Application No : 10/552,376
Applicant : CHEN, Hua
Filed : October 7, 2005
Art Unit : 3745
Examiner : VERDIER, Christopher M.

REPLY BRIEF

Please consider the following Reply Brief in response to an Examiner's Answer in the appeal of the above-identified application. The present Reply Brief is to be considered
10 for the appeal in addition to the Appeal Brief filed April 16, 2010.

Figure from Mitsubori with annotations added

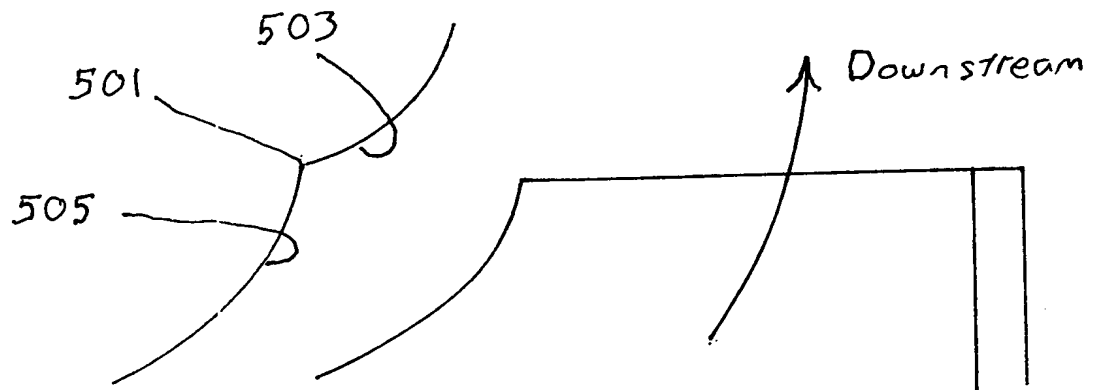
Regarding Argument (a), on the upper half of page 16 (lines 6 – 9), the Examiner's Answer recites that Mutsubori discloses a sharp edge connecting a downstream-facing blocking face (formed by the discontinuity) to a smoothly curving surface C upstream of the blocking face.

A highly enlarged depiction of the relevant portion of the drawing from Mitsubori et al. is replicated below, with additional notations. There is only one discontinuity, which is the sharp edge #501. A downstream-facing face #505 is formed upstream of the sharp edge (and an upstream-facing face #503 is formed downstream of the sharp edge). The Examiner's Answer correctly identifies face C as a smoothly curving surface upstream of the downstream-facing face #505. However, the sharp edge is not between the downstream-facing face #505 and the smoothly curving surface. Therefore, the sharp edge fails to connect a downstream-facing blocking face to a smoothly curving surface upstream of the blocking face. The appellant respectfully traverses the statement in the Examiner's Answer alleging that the claimed features are disclosed.

On the lower half of page 16 through the upper portion of page 18, the Examiner's Answer further argues that certain portions of the specification suggest that the invention should be interpreted broadly, that Fig. 4a must be within the scope of the claims, and therefore that Mitsubori discloses the claim elements. This is argument violates basic rules of claim construction.

Claim 1 explicitly recites a sharp edge connecting a blocking face to a smoothly curving surface upstream of the blocking face. Neither Mitsubori nor Fig. 4a disclose this feature. Because the cited reference fails to disclose the features of claim 1, 15/1 and 18, the Office Action fails to assert a prima facie case of anticipation, and the Appellant respectfully requests the rejections of claims 1, 15/1, and 18 under 35 U.S.C. § 102(b) be reversed.
